From: Paul Farndale
Sent: 05 October 2017 14:17
To: Louise Bearcroft
Cc: 'richard.csmith@btconnect.com'
Subject: FW: Polypipe Attenuation Tank Sizing Using Hydro Brake Optimum Design Head 113 Westfield Lane
Attachments: Poly Attenuation Tank Sizing 4Lt 113 Westfield Lane T-MD-PR266059_JK_MD2 4ls.pdf; Scan_0002.pdf; Scan_0001.pdf; Scan.pdf

113 Westfield Lane 2017/91748

Typical Attenuation
Tank Plan

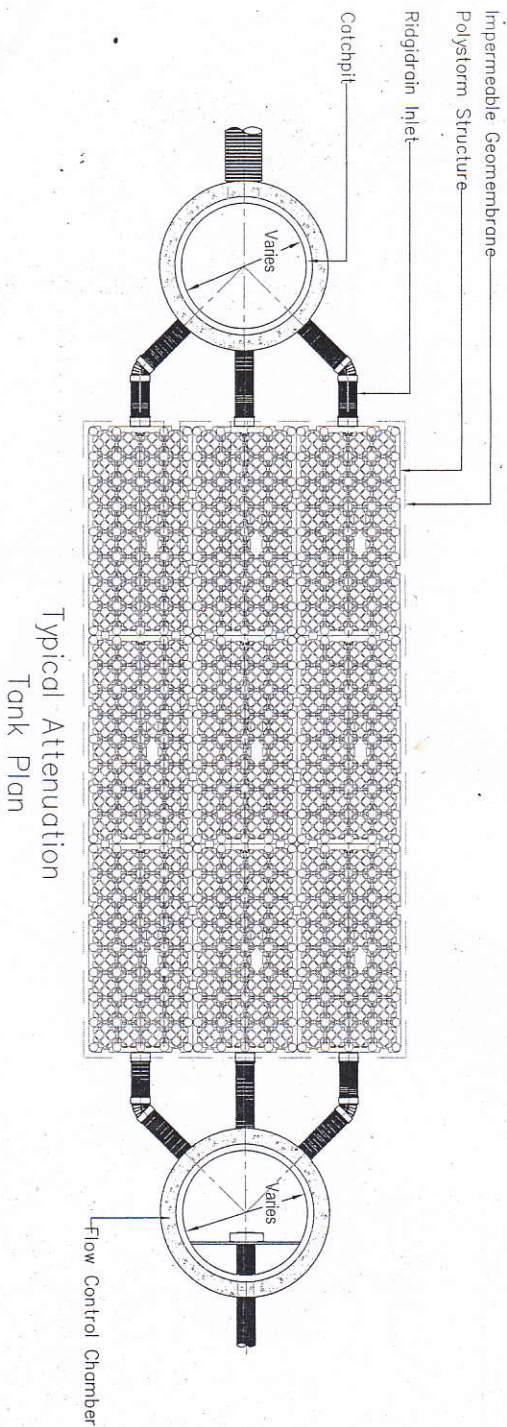
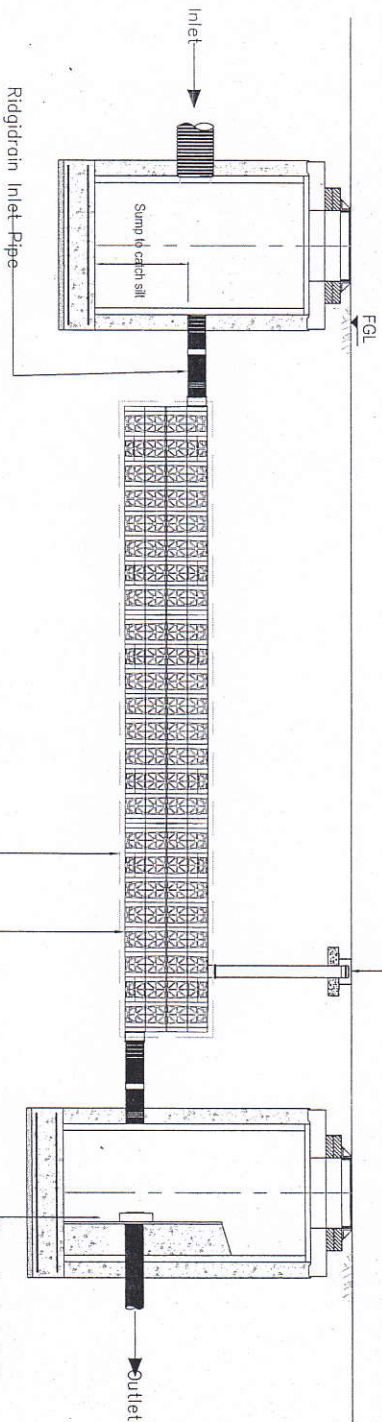
I have had a chance to review the requirements for the attenuation tank sizing and have conducted calculations using the MicroDrainage software using the parameters shown below:

Size of Structure: 1m x 2m x 0.8m

Number of cells (PSM1A): 8 No. (based on appropriate loading conditions)

Flow Control Unit: Hydro Brake Optimum, Design Head: 0.8m, Design Flow: 4l/s

Please can you attach the above submissions so we have an official record of the submission. I appreciate a decision has been made but the above scheme details are sufficient for our drainage requirements.

If an official discharge of condition application is requirement please can you let the applicant know. The above will discharge any drainage condition.

existing drainage layout 1:200

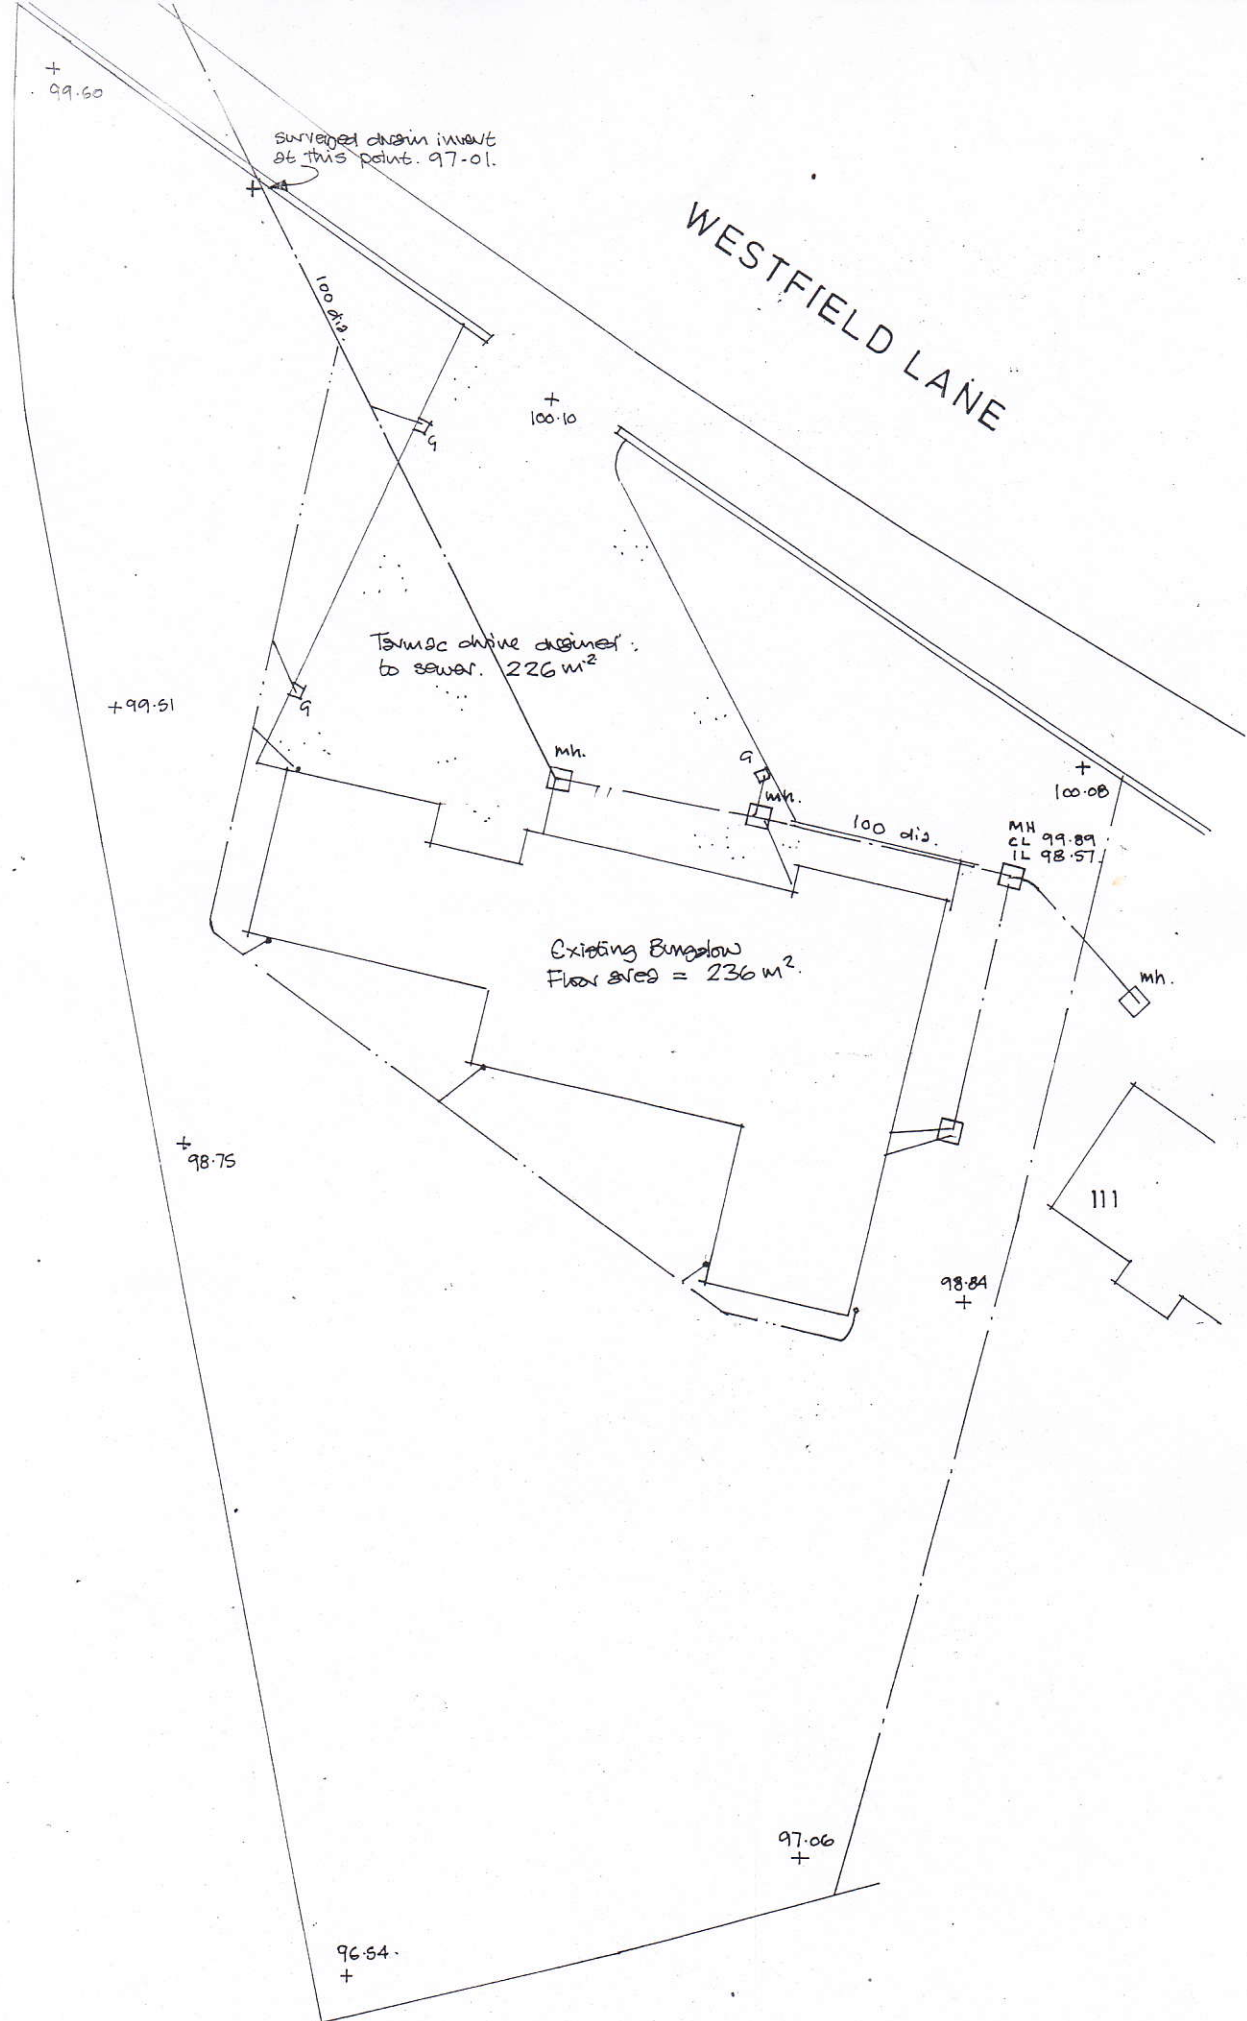
I have altered my plan do you still require a manufacturers detail I think the valve model is specified in the calculations I have sent you, I can ask the developer to ring Polypipe tomorrow and see if they can provide a detail if necessary.

Have you got the most up to date plan to go with this so I can give them in a package to John Ritchie to discharge the condition.

No, just the plan with the sized tank on and the connection will suffice for a development this size.
